**PLAN COMMISSION
MEETING**
April 4, 2022
4:00 PM

PUBLIC MEETING NOTICE

Administrative Staff Report

850 Rosecrans Street

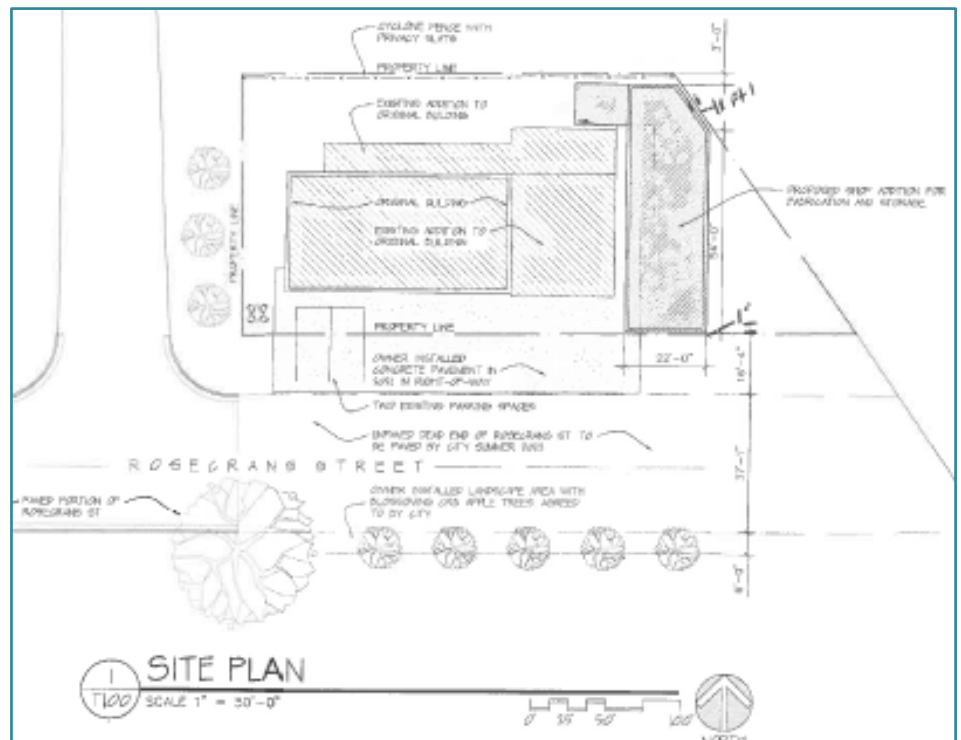
Analysis: Manufacturing is permitted within the General Industrial M-1 Zoning District. The use currently exists and is proposed to be expanded, with the constructed of the proposed accessory building.

Findings: Note that a building plan – architectural review (AR), plan of operation (PO), site plan review (SP), and zoning permit (ZP) are required.

TITLE SHEET
SITE PLAN &
CODE INFORMATION

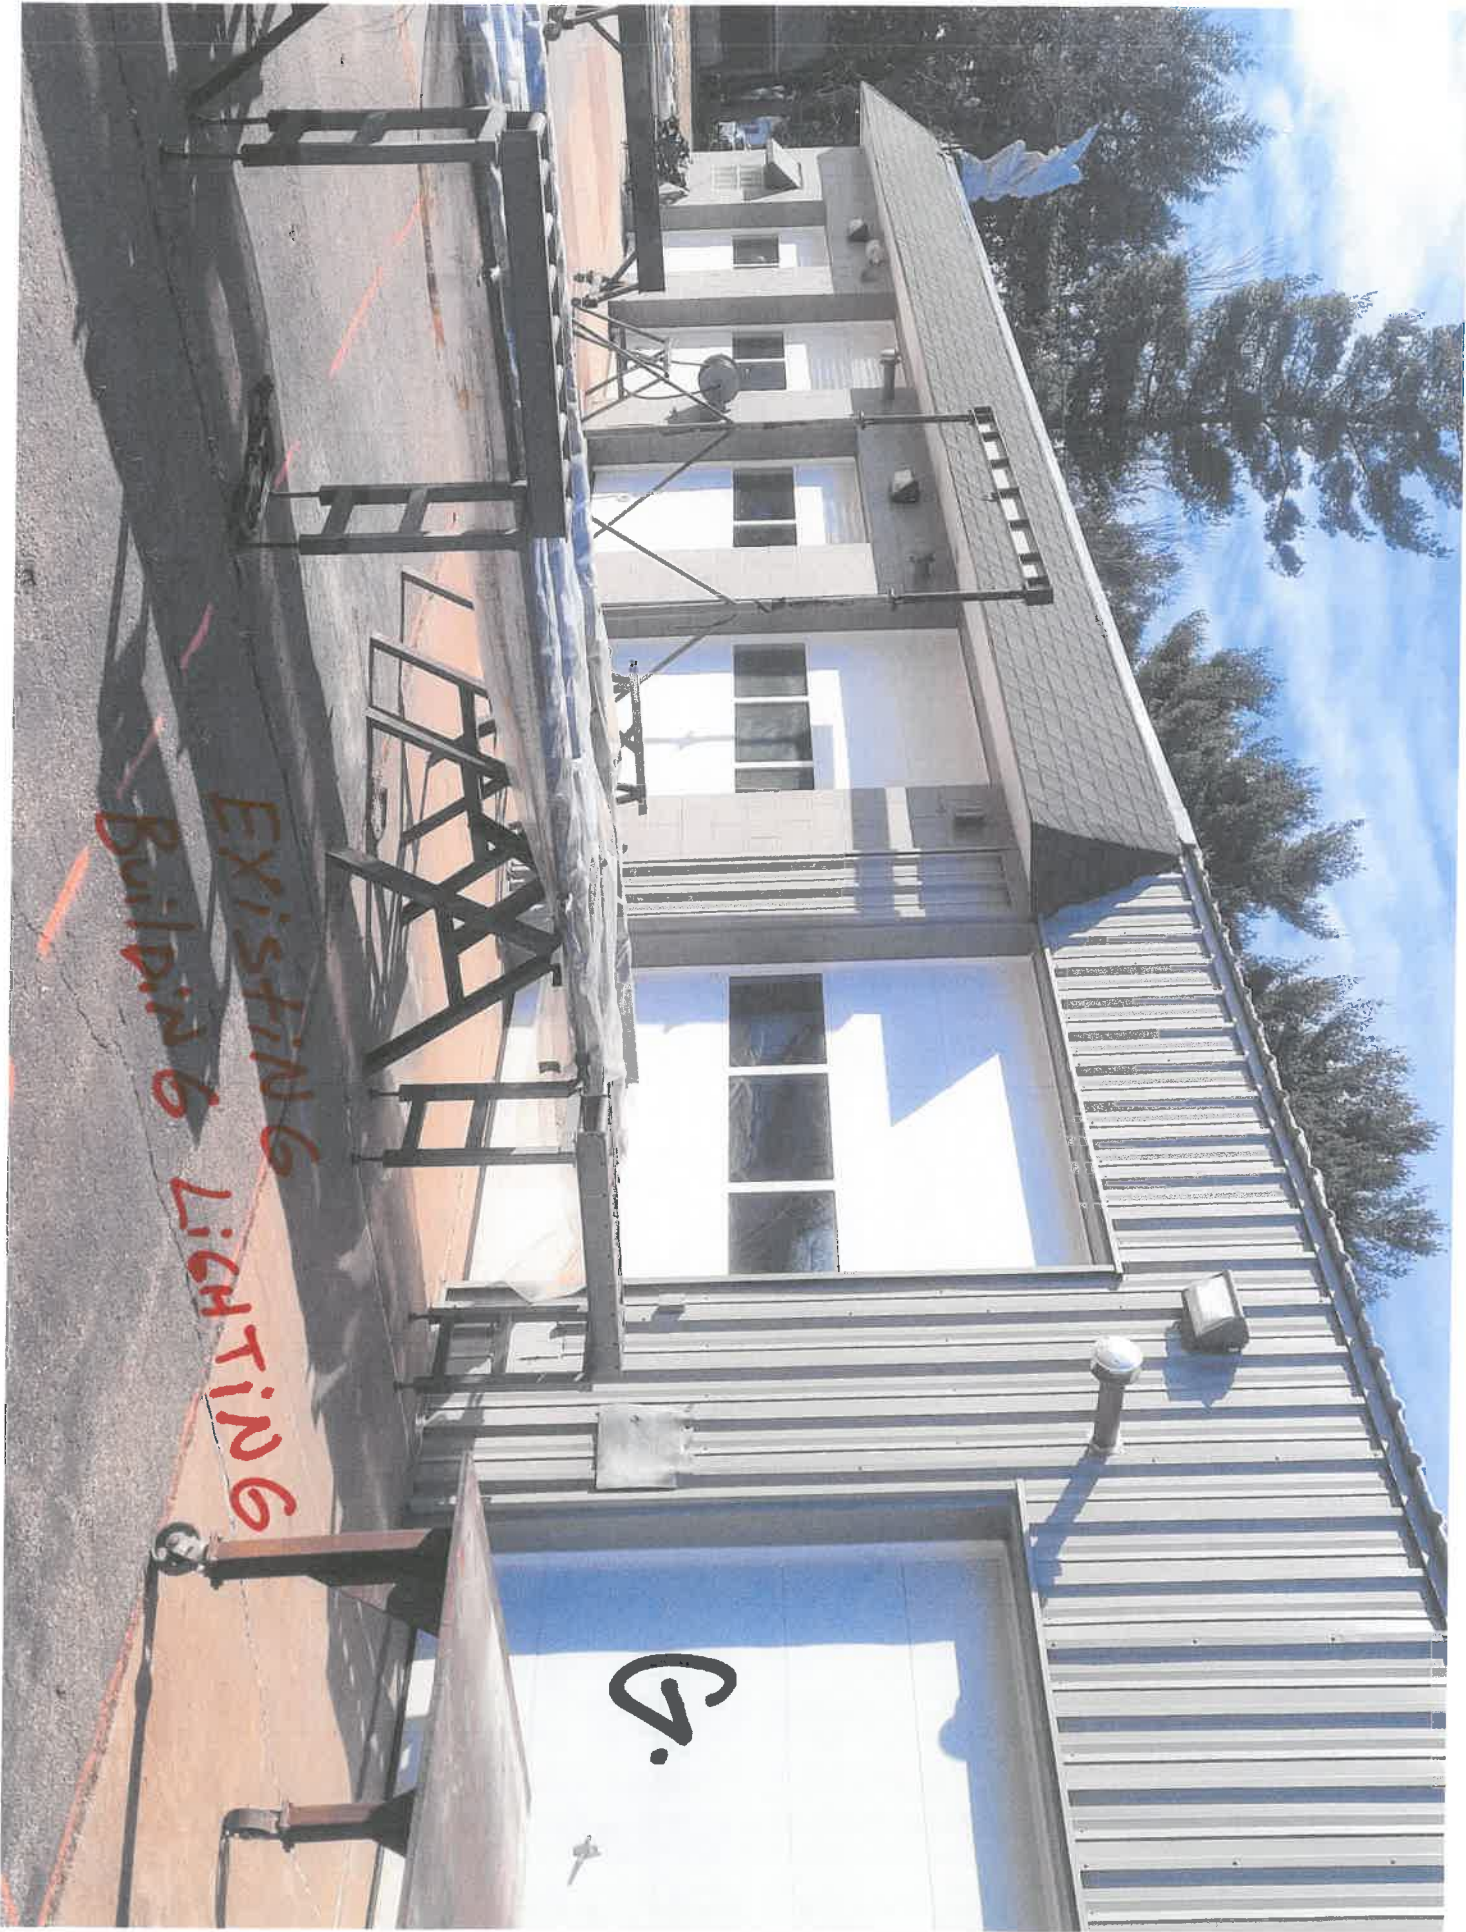
Analysis: The M-1 district requires 40,000 square feet, and the lot is 10,019 square feet. The proposed accessory building is proposed within a permeable area east of the existing building and meets setbacks that were approved as a result of the prior Zoning Board of Appeals (ZBA) decision. An second variance application for additional encroachment will be considered by the Zoning Board of Appeals later this month. The building coverage ratio is 29 percent (70 percent maximum allowed), and the existing impervious surface ratio is approximately 54% (90 percent maximum allowed).

Findings: The building coverage ratio would be approximately 50%, with impervious surface ratio at approximately 68%. The proposed accessory structure meets all required dimensional requirements except for setbacks. The setback encroachment was approved by the prior ZBA decision.

Findings: The applicant would be required to install a paved driveway to provide ingress and egress to the accessory structure. In addition, any additional installed hardscape would need to be reviewed administratively to ensure that impervious surface requirements are met and that parking is shown accordingly. The engineering department may also require review for another driveway.

Findings: The existing business has only one employee. There are two parking spaces on site, therefore the required parking is met.

ELEVATION

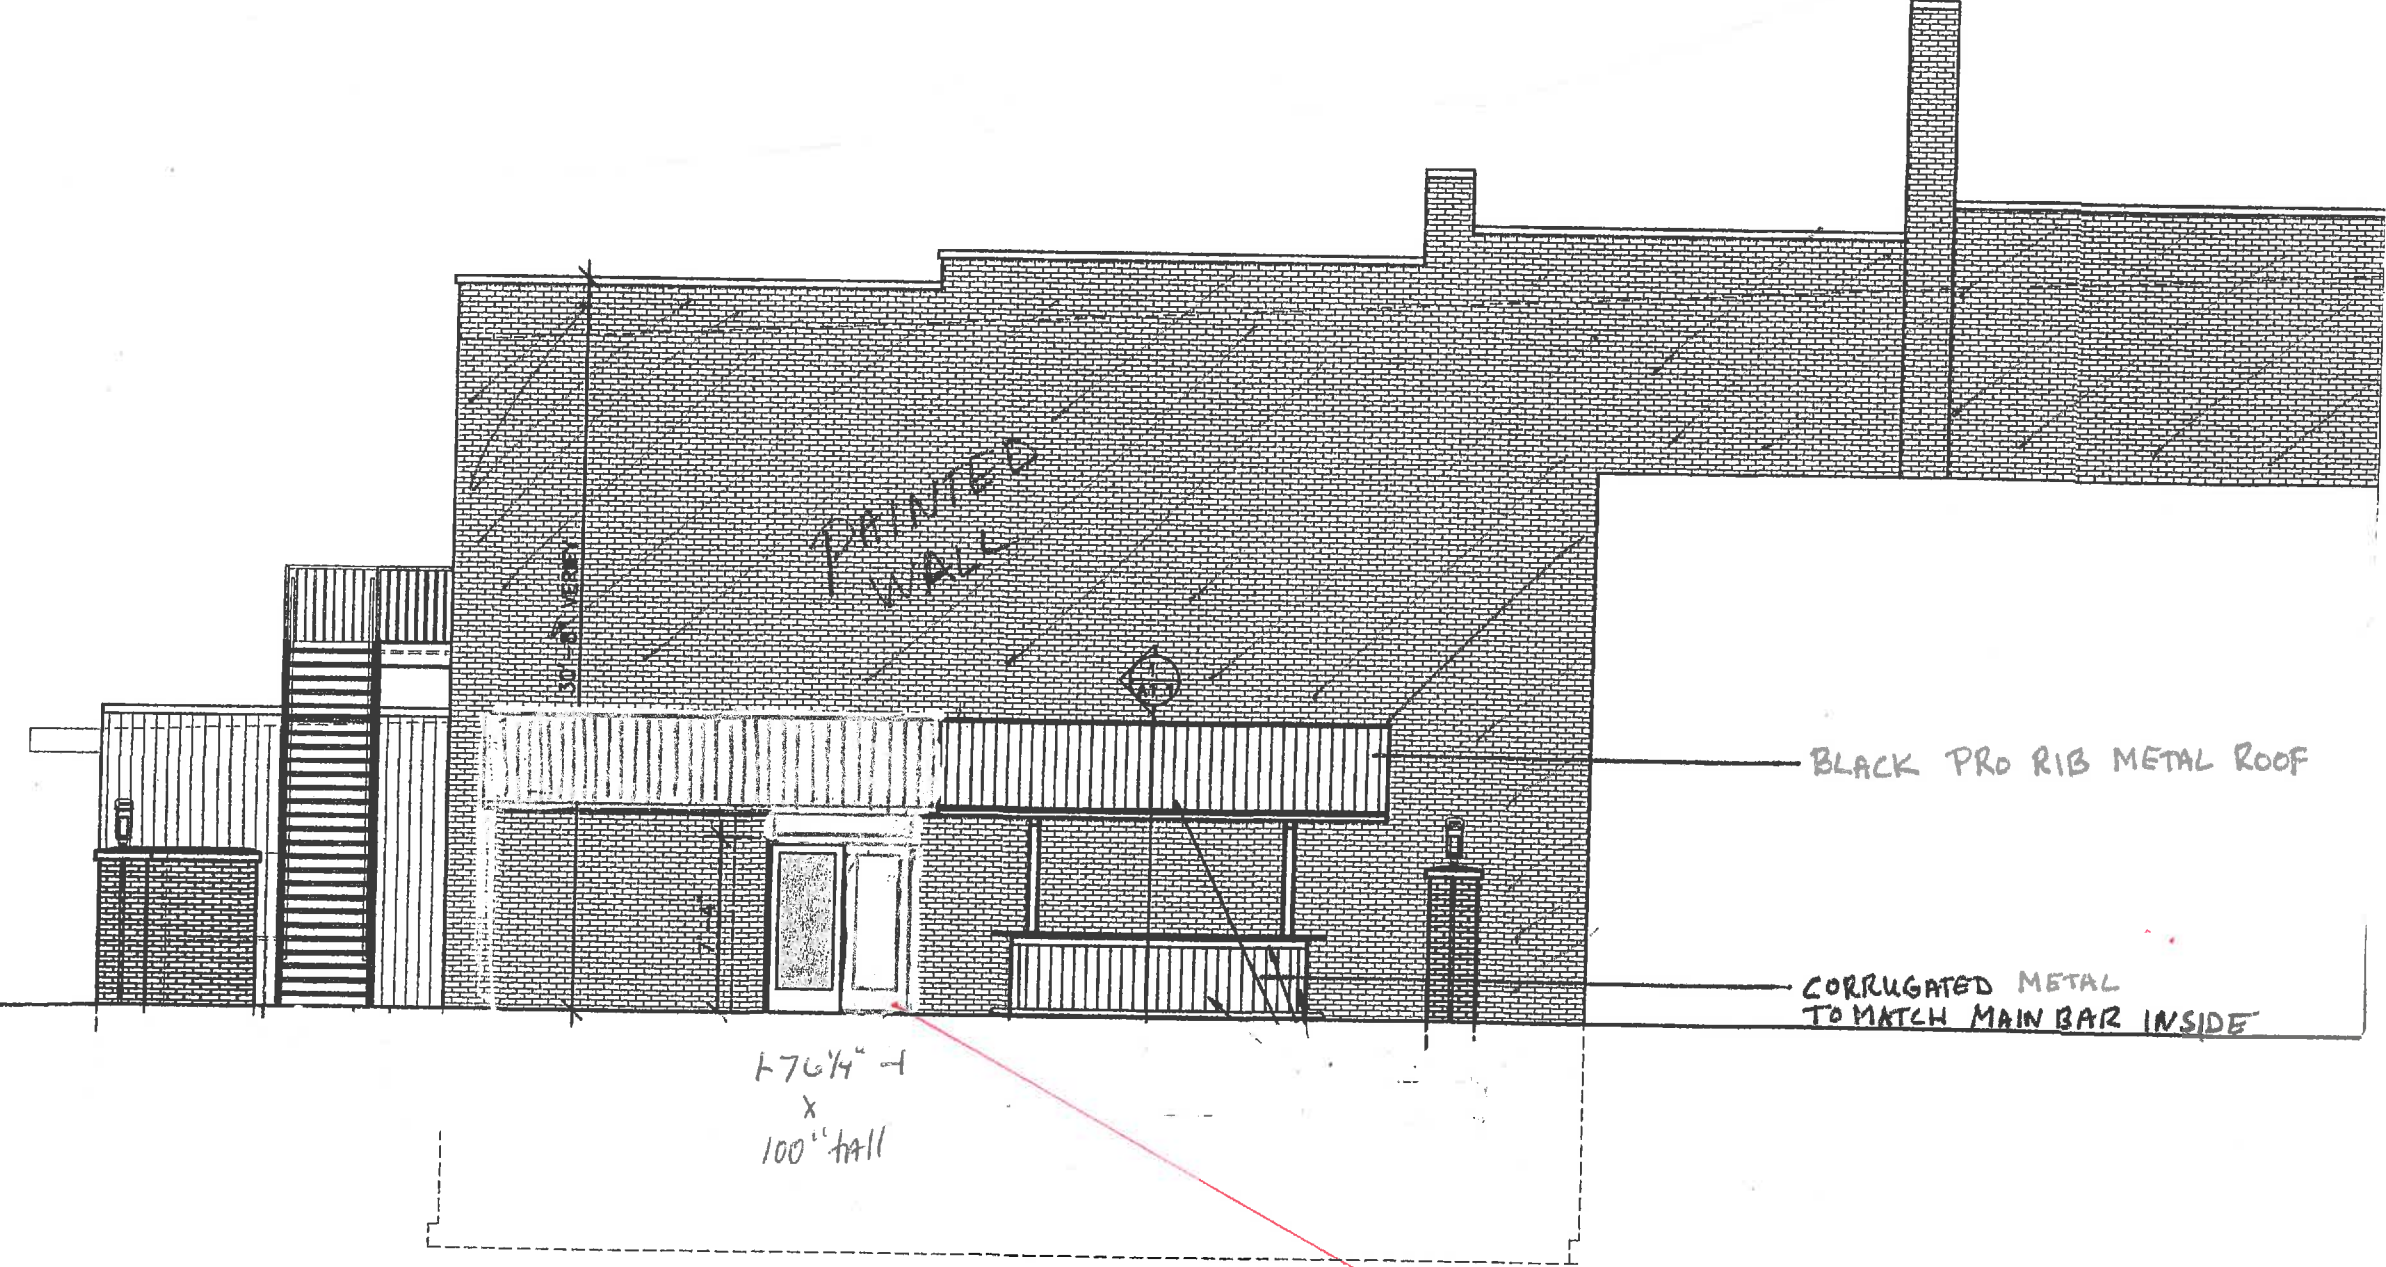
Findings: The proposed door will add character to the northeast façade of the building and as shown in the attached rendering, which is part of an overall improvement project for the adjacent lot.

Findings: The proposed door opening will add to the character and aesthetics of the building. Furthermore, it also directly relates to additional future improvements to the adjacent lot.

1. Minor modifications to the façade improvement can be approved by the Community Development Department.
